**Safety Evaluation Report  
License Renewal of the Kennecott Uranium Company  
Sweetwater Uranium Project, Sweetwater County,  
Wyoming**

Materials License No. SUA-1350

Docket No. 040-08584

**FIGURE 2.** Location of operational monitoring wells in relation to site features and contamination plumes.

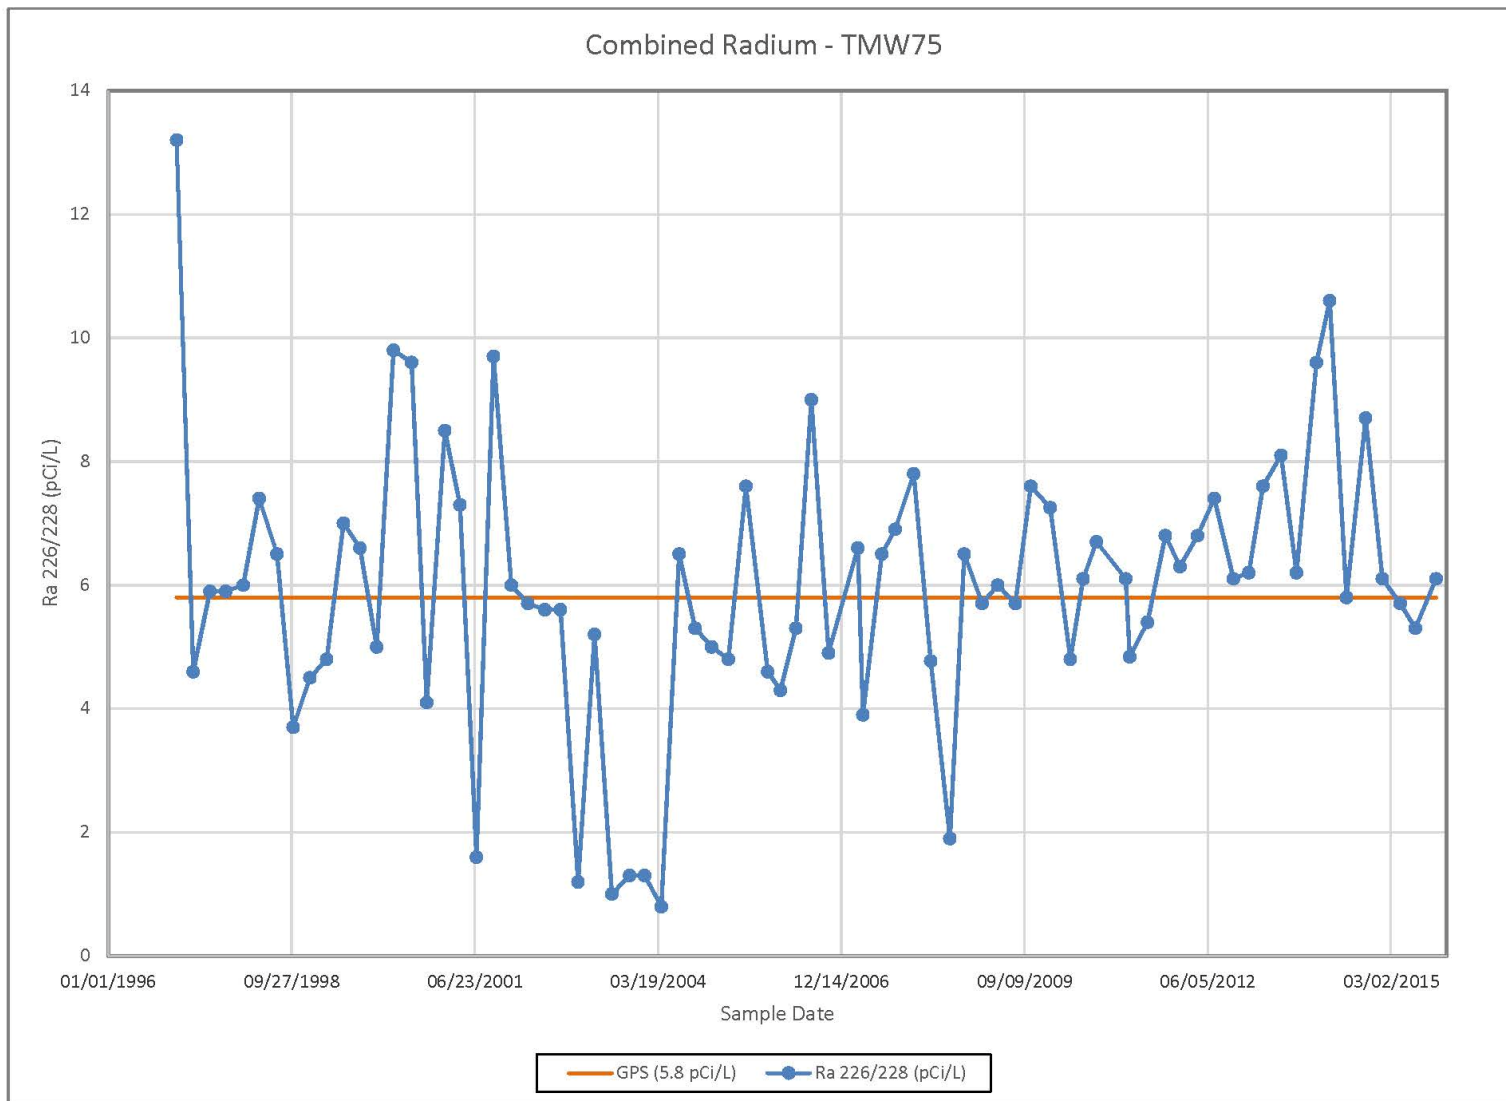
Figure 2 in Appendix A to this attachment shows the location of these wells in relation to the proposed tailings impoundment and the existing combined radium-226/228 and natural uranium ground water plumes, as delineated by KUC in its 2014 Annual Corrective Action Program Review and Groundwater Monitoring Report (ADAMS Accession No. ML15072A366). As shown, well TMW-64 is within the existing combined radium-226/228 ground water plume and, along with well TMW-78, is on the edge of one of the areas of natural uranium contamination. Monitoring well TMW-75 is also within the existing combined radium-226/228 ground water plume, whereas wells TMW-35 and TMW-78 are close to the edge of the combined radium-226/228 plume. The 5.8 picocurie per liter (pCi/L) value for combined radium-226/228 and 36 pCi/L for natural uranium used for plume delineation are the respective ground water protection standards (GPSs) for these constituents KUC requested based on its February 1996 “Background Ground Water Quality and Detection Standards, Addendum to the Revised Environmental Report” (ADAMS PLL Accession No. 9622090095A (microform)). The NRC incorporated these GPSs into a 1998 license amendment and all subsequent license renewals, including the current license (ADAMS Accession No. ML15008A256). Figures 3 and 4 in Appendix A to this attachment are time series plots of the combined radium-226/228 concentrations in wells TMW-64 and TMW-75, respectively, with respect to the corresponding GPS. The data used for the plots were taken from the annual corrective action program (CAP) reviews and ground water monitoring reports that KUC submitted to the NRC. As shown, the combined radium-226/228 concentrations in both wells have exceeded and continue to exceed the GPSs.

**FIGURE 5.** Times series of conductivity values in operational monitoring wells TMW31, TMW75 and TMW78.

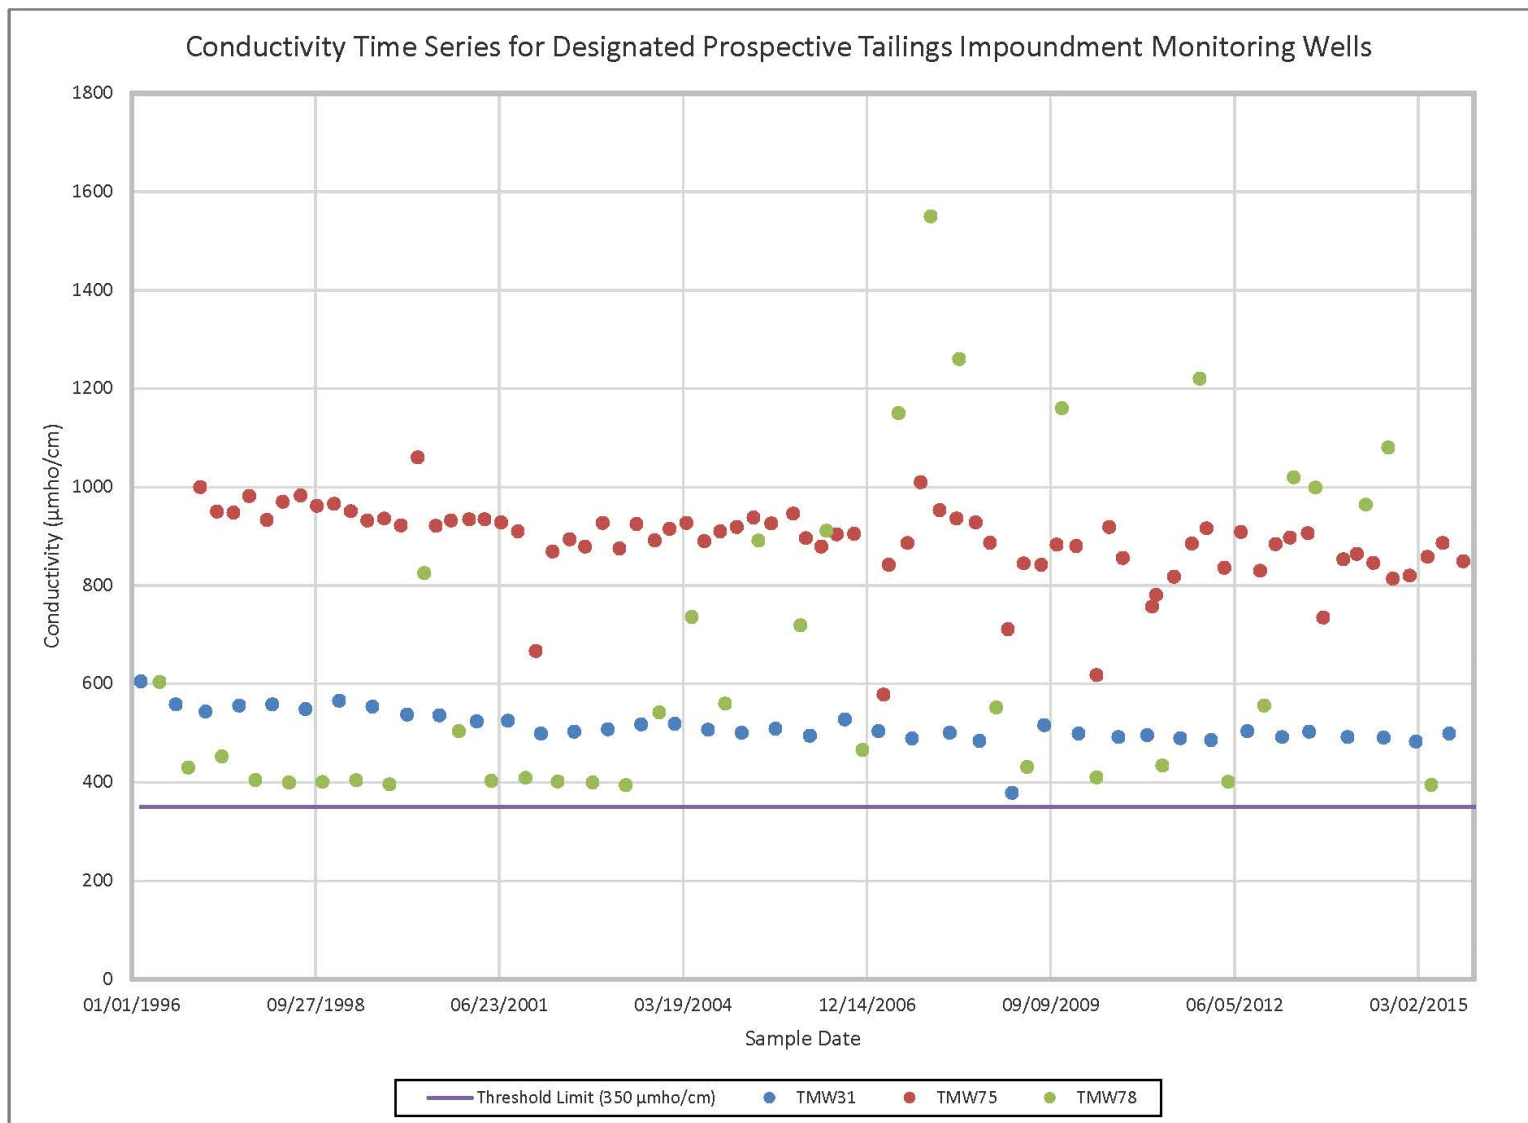
For the purpose of this technical evaluation report, as shown in Figure 5 in Appendix A to this attachment, the NRC staff plotted period-of-record time series of conductivity values for the three POC wells previously designated to monitor this parameter. The data used for the plots were taken from the annual CAP review and ground water monitoring reports KUC submitted to the NRC. But conductivity values for all three wells have continued to consistently and significantly exceeded the previously approved 350  $\mu\text{mho/cm}$  detection standard. This analysis thus indicates the following:

FIGURE 6. Location of evaporation ponds monitoring well TMW50 relative to potentiometric and contamination plume contours.

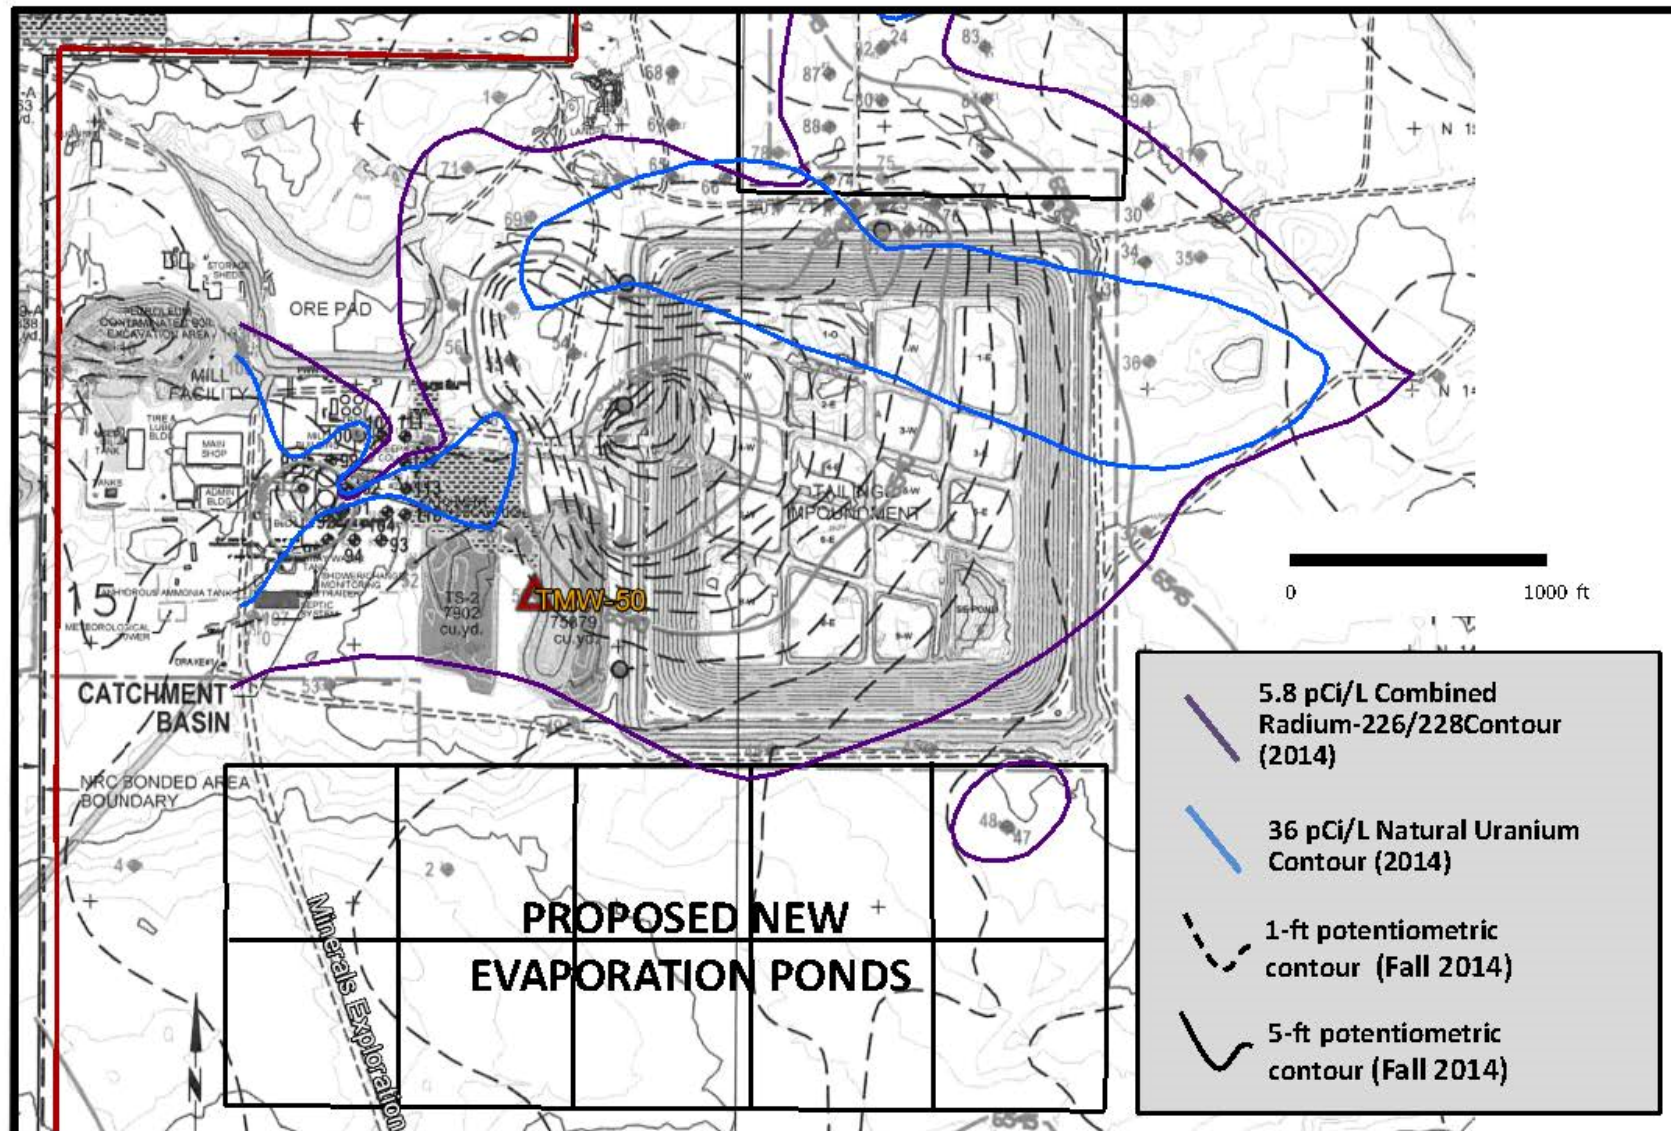
Thus, the intended use of well TMW-50 at the time was as an upgradient monitoring well to the evaporation ponds, given that ground water flow was toward the southwest (as stated on page 21 of the same document). The NRC staff notes that the ground water flow direction across the facility has since changed due to pumping activities related to the CAP for the site. Figure 6 in Appendix A to this attachment shows the location of well TMW-50, the potentiometric surface from the Fall of 2014, and the combined radium-226/228 and natural uranium plumes from 2014. The information in the figure was obtained from the KUC 2014 “Corrective Action Program Review and Groundwater Monitoring Report” (ADAMS Accession No. ML15072A366). As indicated by the potentiometric head contours in Figure 6 in Appendix A, ground water flow at the well location is currently toward the northeast, and the well is no longer upgradient of the proposed evaporation ponds. Also shown in the figure, Well TMW-50 is also within the combined radium-226/228 plume area. A period-of-record time series plot of combined radium-226/228 concentrations for well TMW-50 (Figure 7 in Appendix A to this attachment) shows that the well continues to exceed the GPSs. The well has also consistently exceeded the 350  $\mu\text{mho/cm}$  detection standard specified in Table 6 from the previously discussed “Addendum to the Revised Environmental Report, Background Ground Water Quality and Detection Standards (see Appendix B to this attachment).

FIGURE 18. Synoptic view of Mann-Kendall trend analysis results for combined radium concentrations.

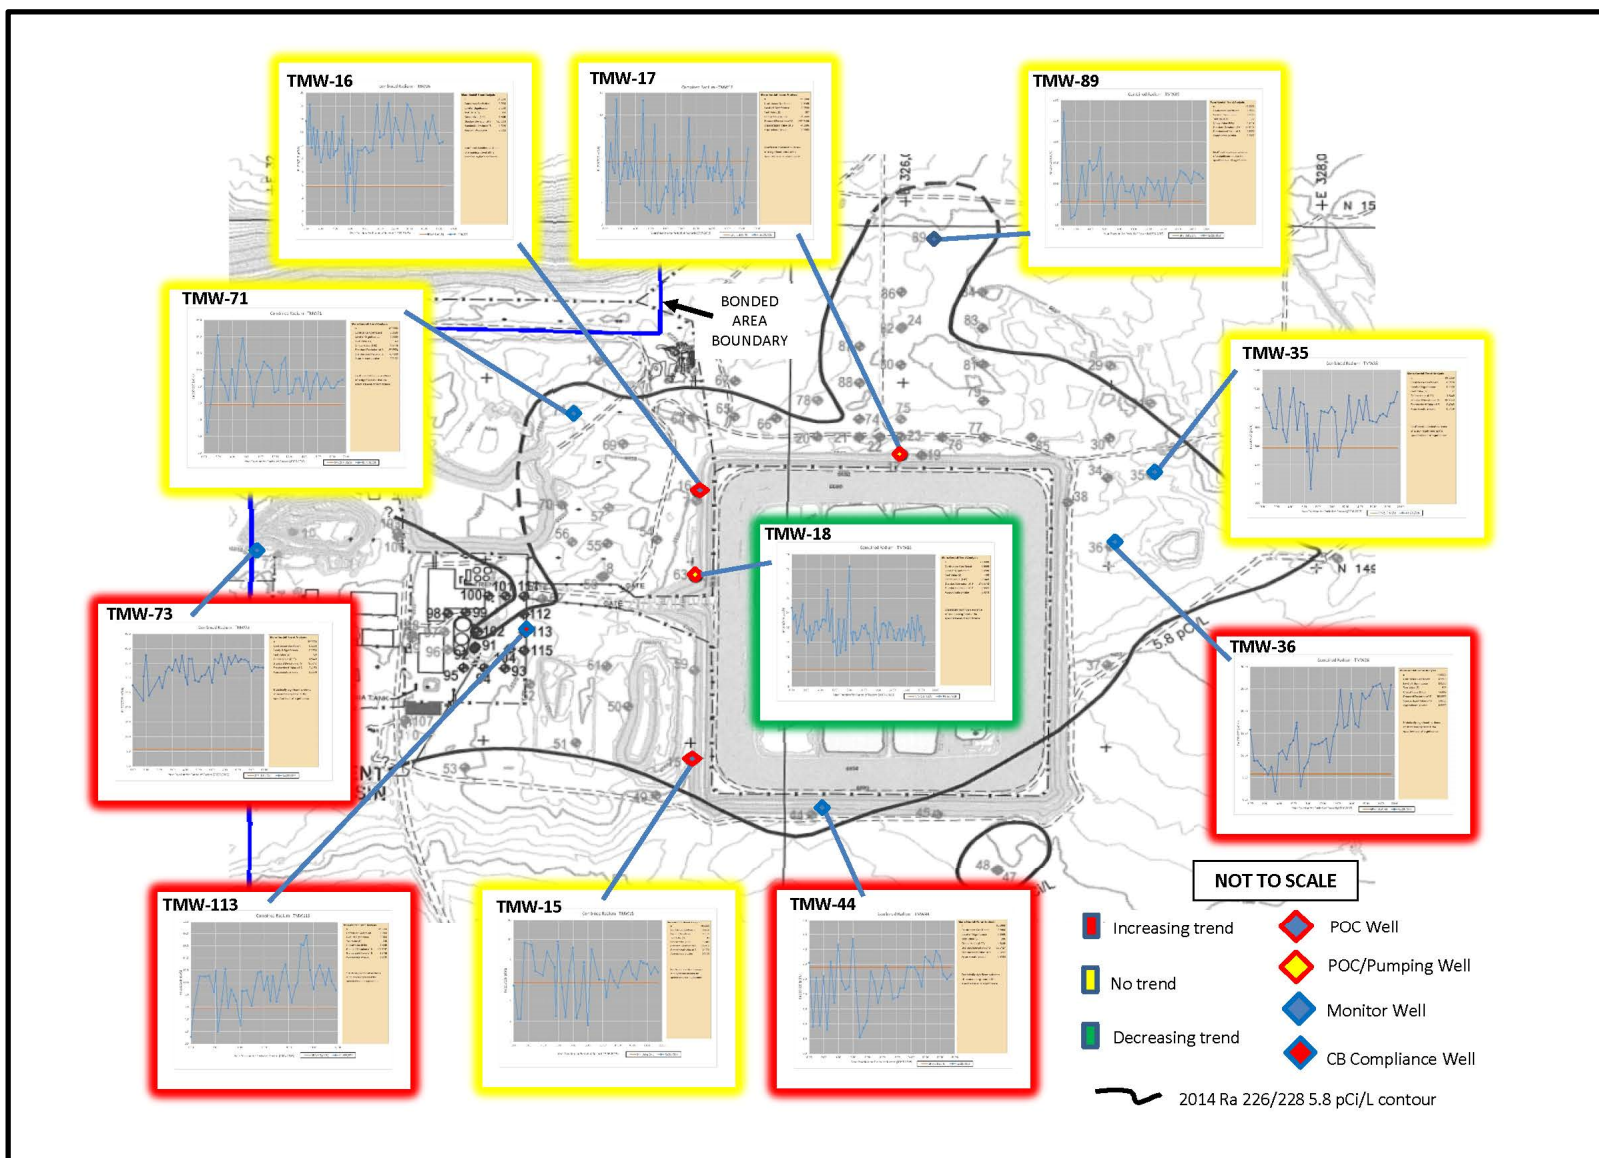
Time series plots for combined radium-226/228 in relation to the 5.8 pCi/L GPS and the associated trend analysis results are presented in Figures 6–17 in Appendix A to this attachment. A synoptic view of these results is shown in Figure 18 in relation to KUC's delineation of the area encompassed by the 5.8 pCi/L isocontour. Especially noteworthy are the wells close to the edge of the plume, which, if the plume were shrinking, would be expected to be exhibiting decreasing trends over time. In fact, none exhibit statistical evidence of a decreasing trend. Among the tailings impoundment POC wells, only combined radium-226/228 concentrations in Well TMW-18 exhibits a statistically significant decreasing trend, although the concentrations remain at least 3 time higher than the GPS. As shown in Figures 4 and 18 in Appendix A, the combined radium-226/228 isocontour for 5.8 pCi/L is not defined on the western side of the facility within 213 m (700 ft) of the bonded area boundary. Thus, the extent to which the combined radium-226-/228 plume may extend beyond the bonded area has not been characterized. Wells TMW-73 and TMW-72 are presently the westernmost wells alongside the plume and adjacent to the edge of the bonded area. These wells are located approximately 32 m (106 ft) apart, with Well TMW-73 screened a foot deeper than Well TMW-72 (ADAMS Accession No. ML14077A340). While Well TMW-72 exhibits exceedances that are less than twice the GPS and a decreasing trend (see Figure 14 in Appendix A to this attachment), combined radium-226/228 concentrations in Well TMW-73 exhibit an increasing trend and are more than 5 times greater than the GPS (see Figure 15 in Appendix A to this attachment). The reason for these discrepancies is unknown. Further characterization of the western extent of the combined radium-226/228 plume is necessary to understand these significant discrepancies.

FIGURE 25. Synoptic view of Mann-Kendall trend analysis results for natural uranium concentrations.

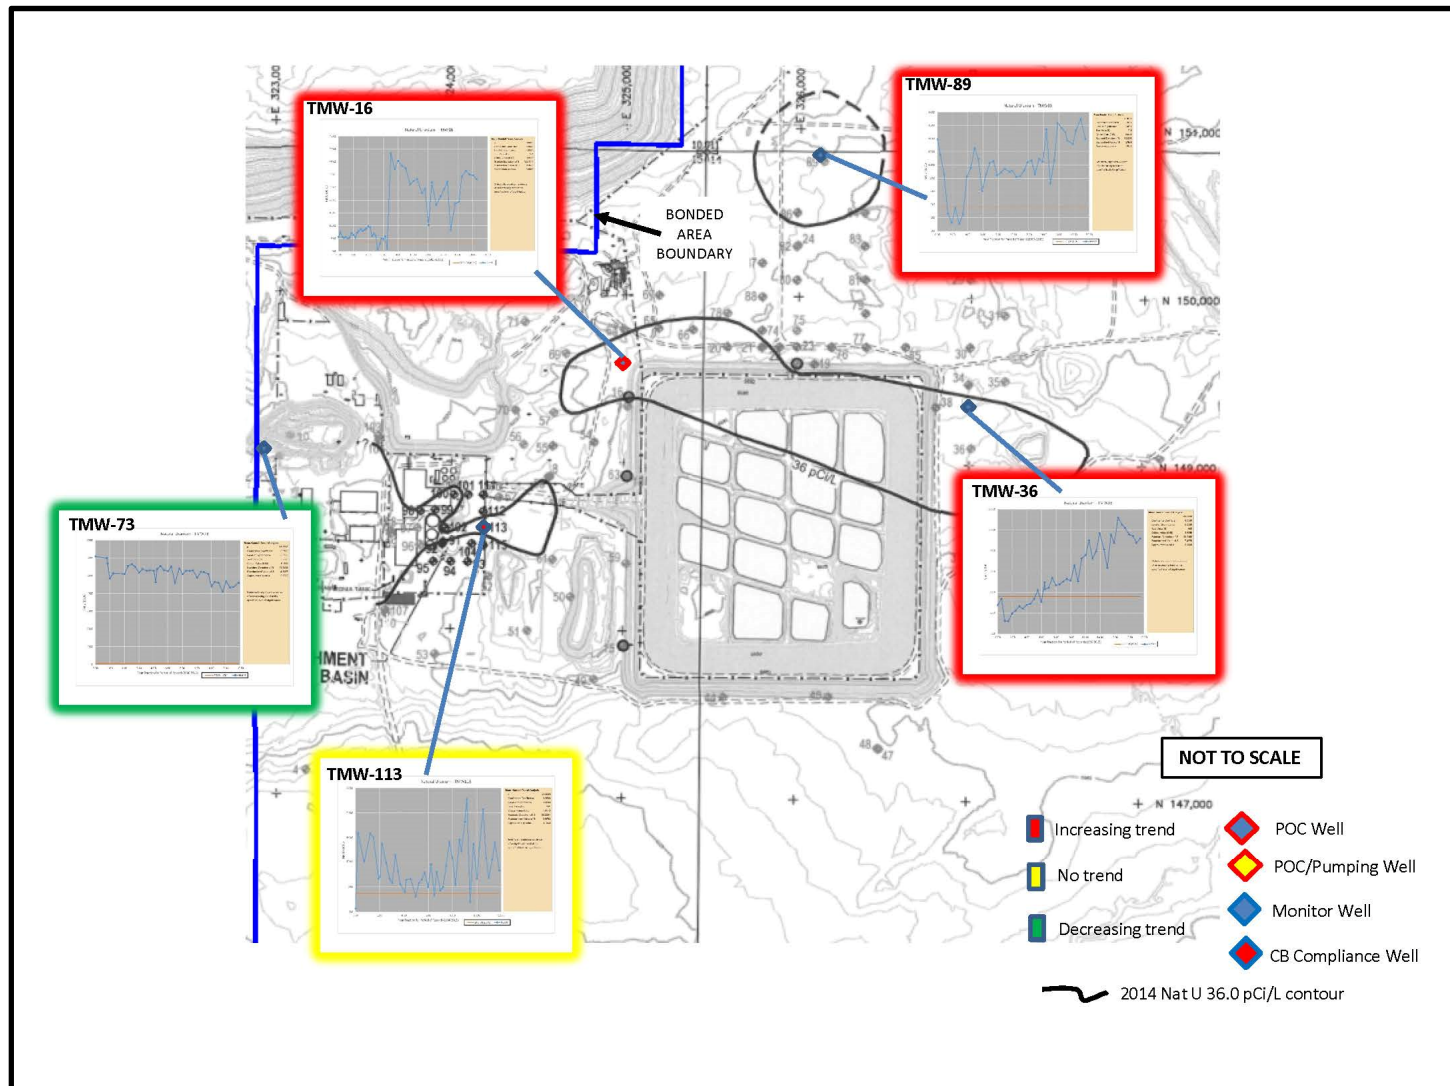
Time series plots for natural uranium in relation to the 36 pCi/L GPS and the associated trend analysis results are presented in Figures 19–24 in Appendix A to this attachment. A synoptic view of these results is shown in Figure 25 in relation to KUC's delineation of the areas encompassed by the 36 pCi/L isocontours. As shown in Figures 5 and 25, three distinct areas of contamination are indicated: one some distance north of the tailings impoundment, the second overlying the northern portion of the tailings impoundment, and the third in proximity to the catchment basin of undefined extent to the west within 213 m (700 ft) of the bonded area boundary. Thus, as with the combined radium plume, the extent to which the natural uranium plume may extend beyond the bonded area has not been characterized. Nearby Well TMW-72 has concentrations of natural uranium that are an order of magnitude higher than the GPS and exhibit no statistically significant trend (see Figure 21 in Appendix A to this attachment). Natural uranium concentrations in westernmost Well TMW-73, adjacent to the bonded area boundary, exhibits a decreasing trend, although it remains 2 orders of magnitude higher than the GPS (see Figure 22 in Appendix A to this attachment). In the area around the catchment basin, easternmost Well TMW-113 is characterized by natural uranium concentrations that exceed the GPS by up to a factor of 6 and exhibits no statistically significant trend. In the two northern areas, Wells TMW-16, TMW-36, and TMW-89 exceed the GPS by up to an order of magnitude, and show statistically significant upward trends.
